CITY OF ALBUQUERQUE

SUBJECT: LOS TOMASES

**RE: LOS TOMASES (H14-D80) GRADING PLAN SUBMITTAL FOR GRADING
PERMIT. ENGINEER'S STAMP DATED 4-19-96.**

RE: LOS TOMASES (H14-D80) DRAINAGE REPORT AND PLAN FOR SITE DEVELOPMENT FOR SUBDIVISION, SITE DEVELOPMENT FOR BUILDING PERMIT, FINAL PLAT, AND GRADING PERMIT. ENGINEER'S STAMP DATED 3-23-96.

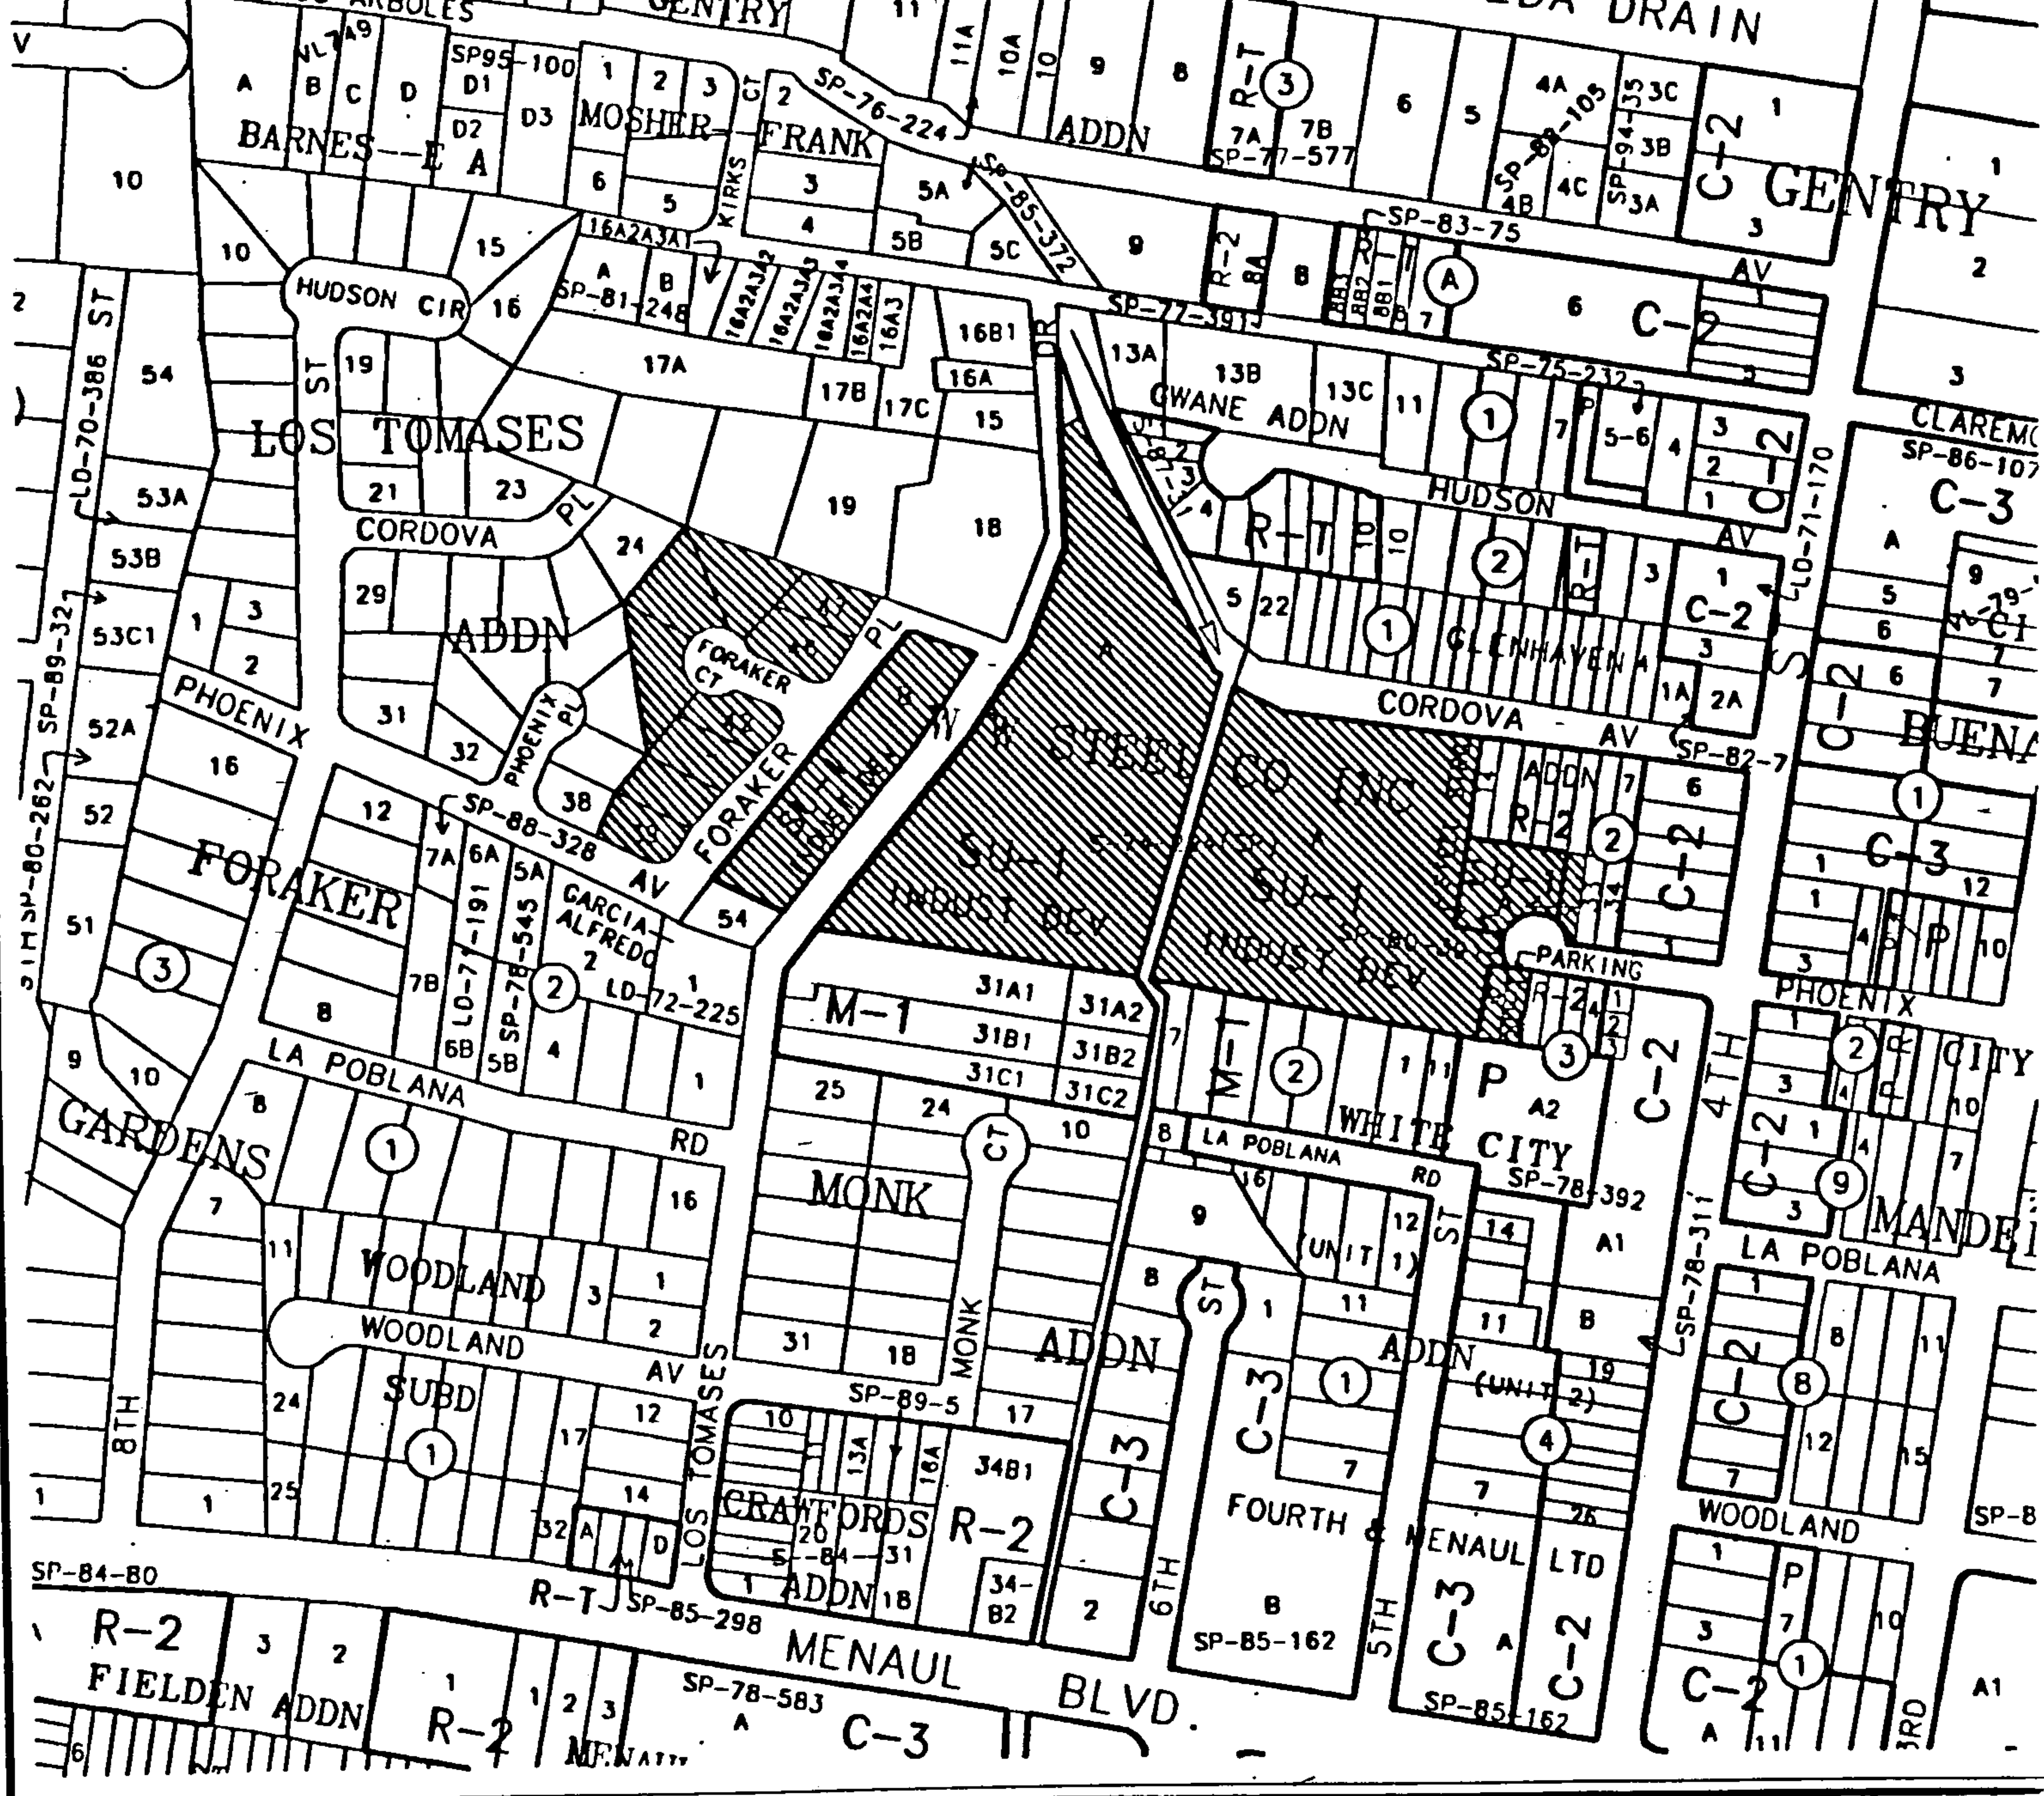
*24 hours?
we don't know this!*
